ADDENDUM NUMBER ONE (1)

Project: "The Commons" Buildings
Hinds Community College – Rankin Campus
Pearl, MS
HCC Bid #3307
PN: 24053

FROM: Dean Architecture, P.A.
661 Sunnybrook Road, Suite 140
Ridgeland, MS 39157
(601) 939-7717

TYPICAL WALL SECTION
N.T.S.

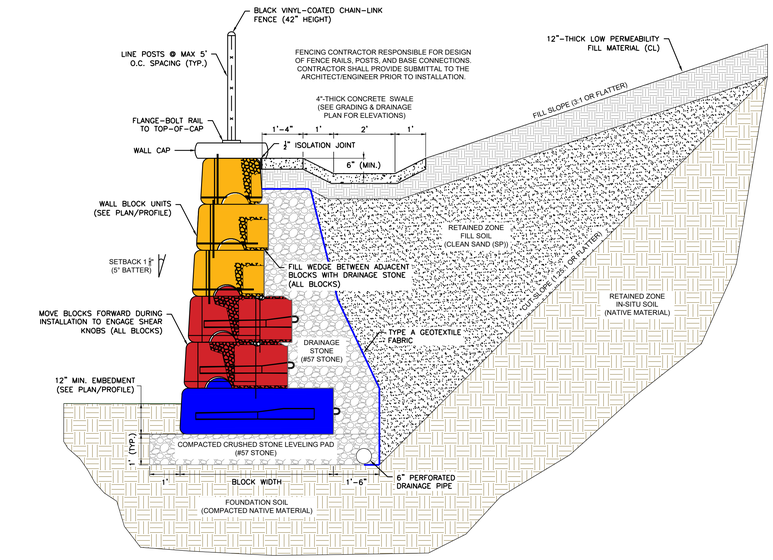
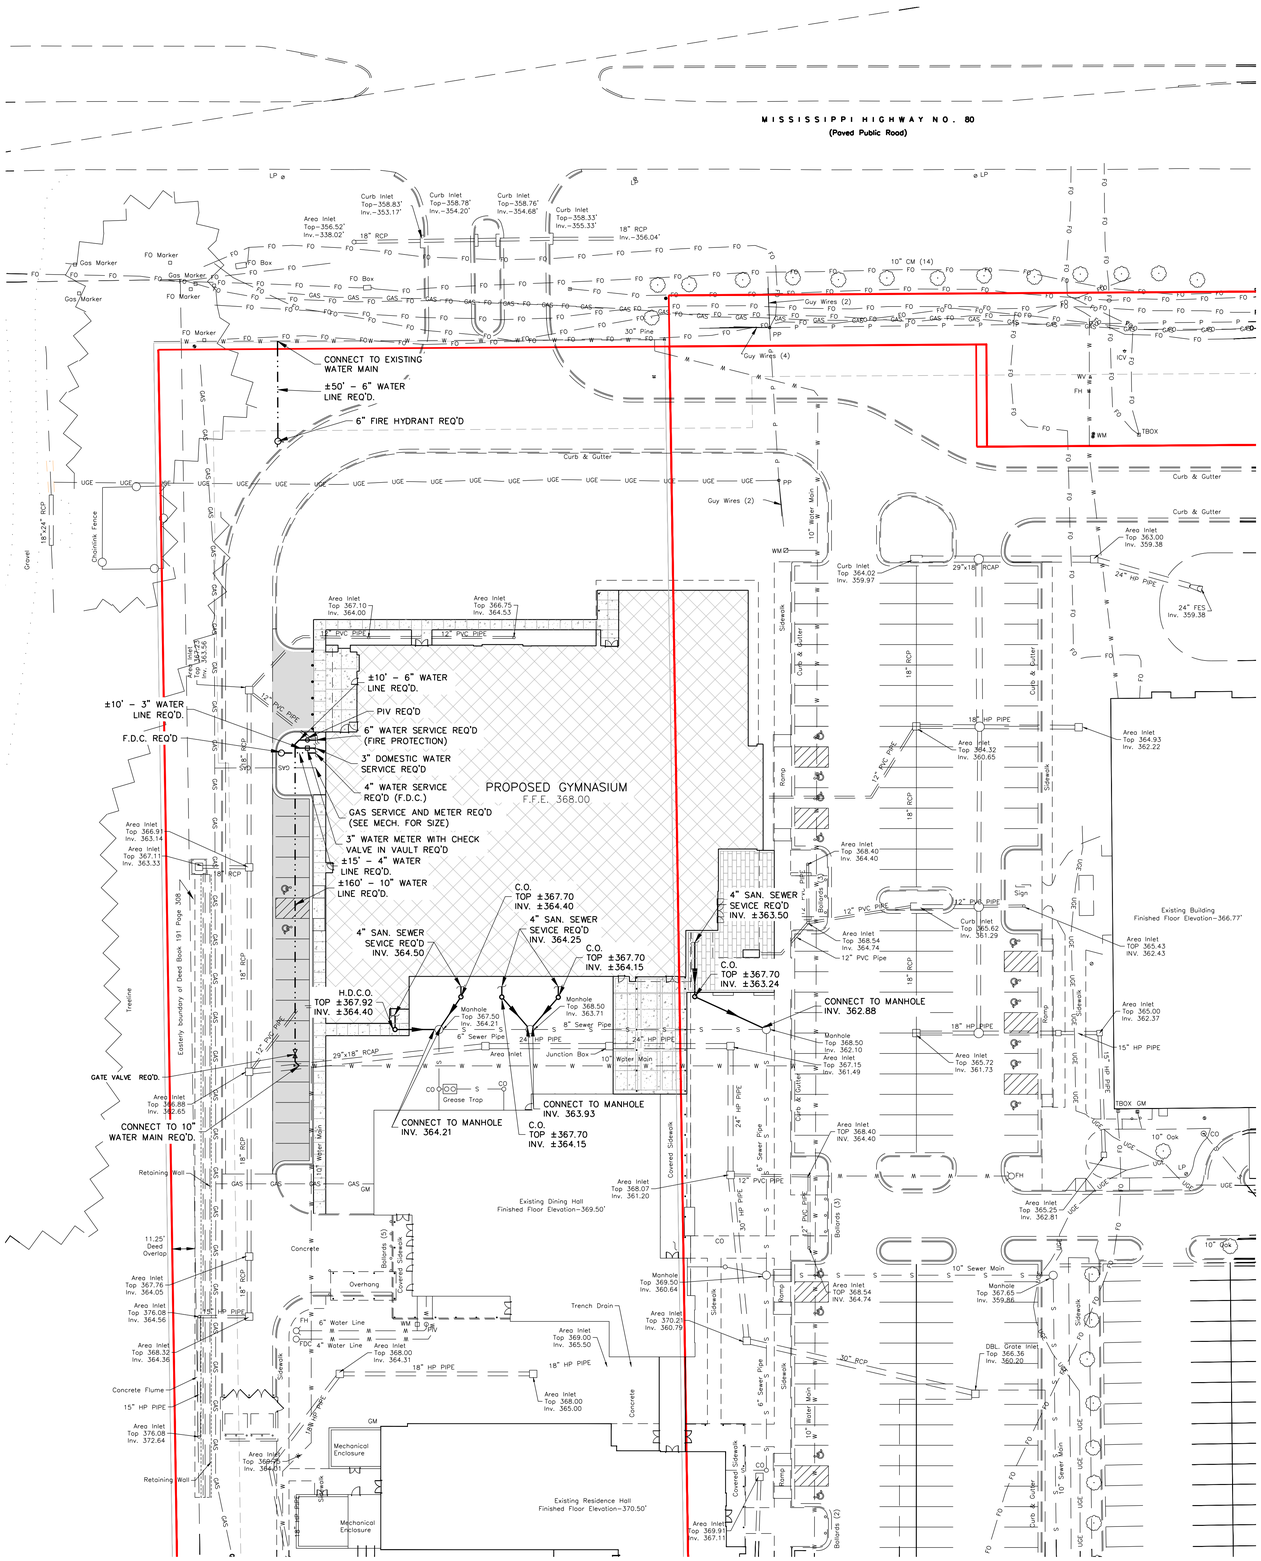
1.9 Item #6 – Sheet C501 Package A – Revised wall design and excavation limits per geotechnical report. Added fence along top of wall.
1.10 Item #7 – Sheet C 502 Package A – Revised notes and typical section.
